ADMINISTRATIVE AMENDMENT

SAFStor Storage
106th & Central Ave SW
Albuquerque, NM

Landscape Design Development

LS-101

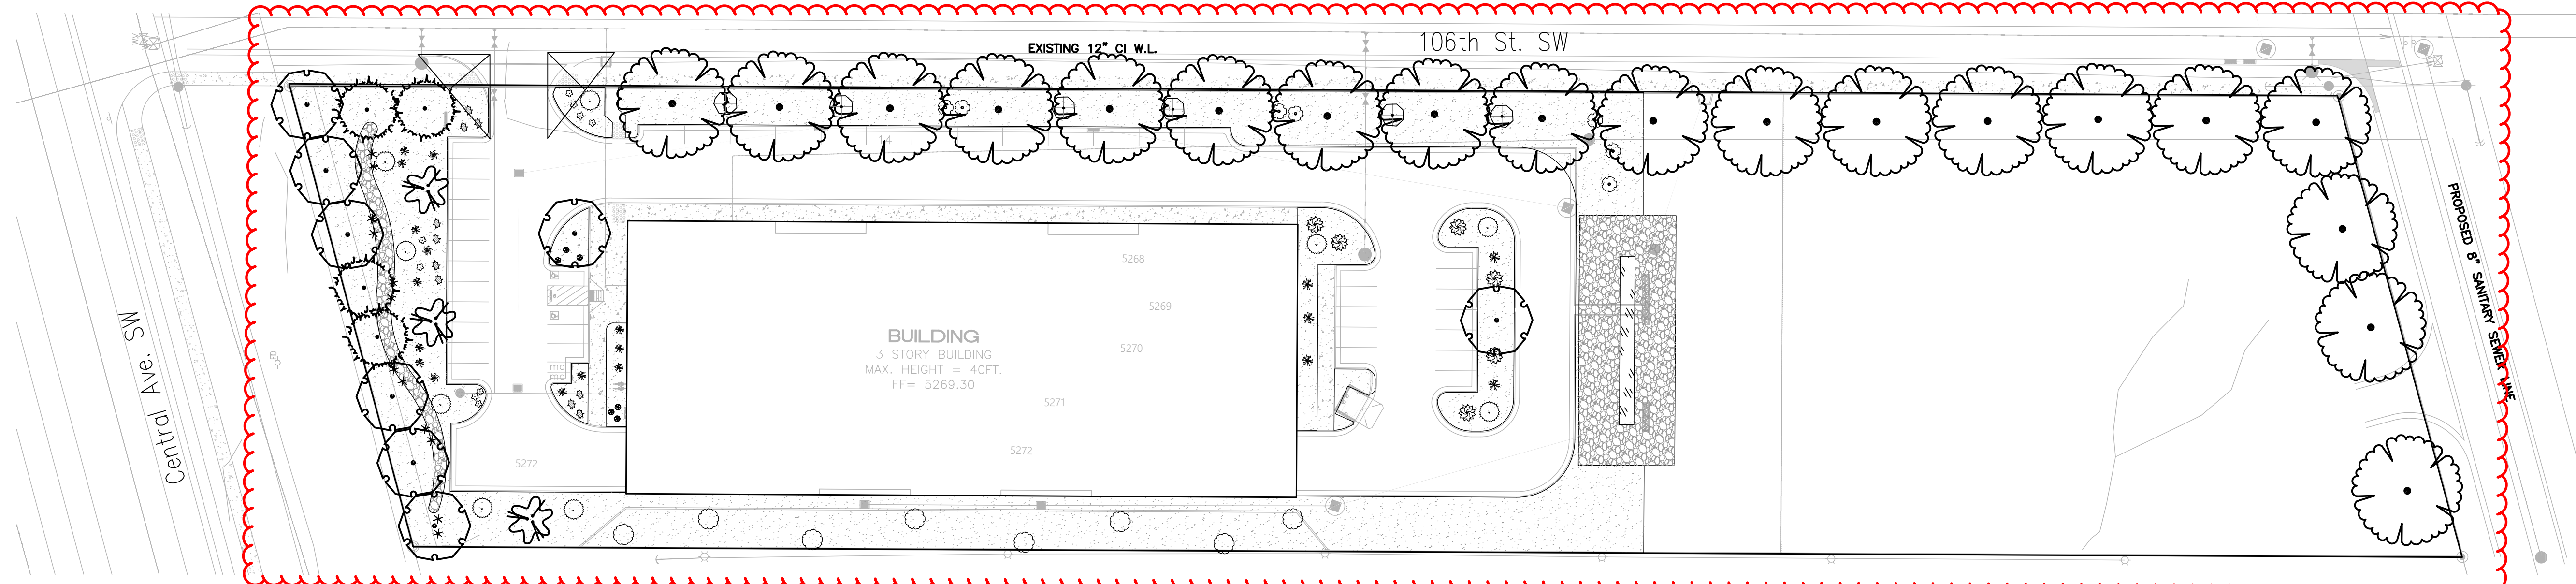
Revised landscape provided (above/beyond required).

Reduced landscape quantities.

Reduced landscape quantities.

Reduced landscape quantities.

1. Remove **three (3)** Sensation Box Elders.
2. Remove **six (6)** Desert Willows.
3. Remove **four (4)** New Mexico Olives.
4. Add **eight (8)** Honey Locusts.
5. Remove **twenty (20)** Austrian Pines.
6. Remove **twelve (12)** Chinese Pistaches.
7. Remove **one (1)** Chaste Trees.

1. Remove **fifty-four (54)** Blue Mist Spireas.
2. Remove **seven (7)** Althea / Rose of Sharons.
3. Remove **ten (10)** Sotols.
4. Remove **fifteen (15)** Red Yuccas.
5. Remove **forty-four (44)** Morning Light Maidengrass'.
6. Remove **thirty (3)** Regal Mists.
7. Remove **sixty-three (58)** Feather Reed Grass'.
8. Remove **forty-nine (49)** Three-Leaf Sumacs.
9. Remove **forty (40)** Pink Double Knock Out Roses.
10. Remove **six (6)** Autumn Cherry Sages.
11. Add **six (6)** Dwarf Butterfly Bushes.
12. Add **eight (8)** Alder-Leaf Mountain Mahoganys.
13. Add **six (6)** Grey-Leaf Cotoneasters.
14. Add **three (3)** Sotols.
15. Add **seven (7)** Manhattan Eunonymus.

Please note the above changes were for a value-engineered landscape plan requested by the customer and that all requirements are still met. The below statistics are dictated on the revised drawings as well:

1. Required Landscape SF: 22,108
2. **Provided Landscape SF: 42,057**
3. Required Vegetative Cover SF: 16,581
4. **Provided Vegetative Cover SF: 51,925**
5. Required Groundcover SF: 4,145
6. **Provided Groundcover SF: 4,404**
7. Required Parking Landscape SF: 720
8. **Provided Parking Landscape SF: 9,875**
9. Required Parking Trees: 5
10. **Provided Parking Trees: 8**
